Product Change Notification Letter

This letter is to inform you of changes to our 4816 series of electromechanical counter line that you have purchased in the past.

Models – P2-4816, P8-4816, V2-4816 and V8-4816

Dimensional Differences: Old model – 4816 Series New model – 4916 Series

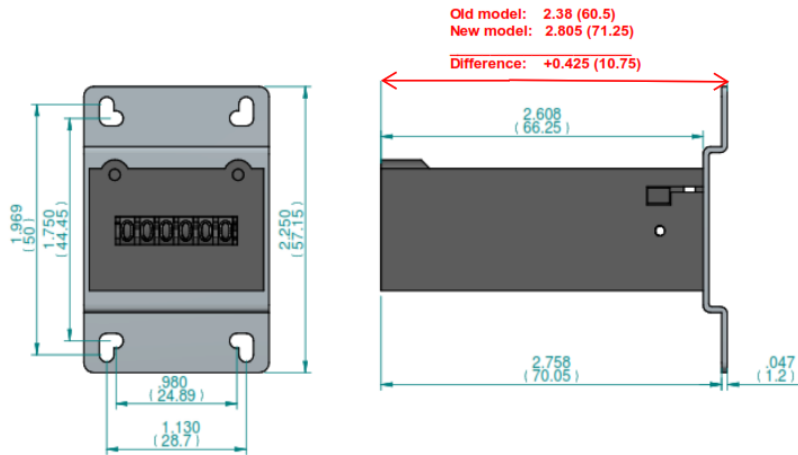
Notification: Description of Change: The 4916 series has slight dimensional changes from the 4816 series. Please see dimension differences in red. The model 4816 series could totalize 1000 counts per minutes whereas the 4916 series can totalize 600 counts per minute

Recommended Action: Update ordering codes to our 4916 series for future purchase orders, see cross reference guide.
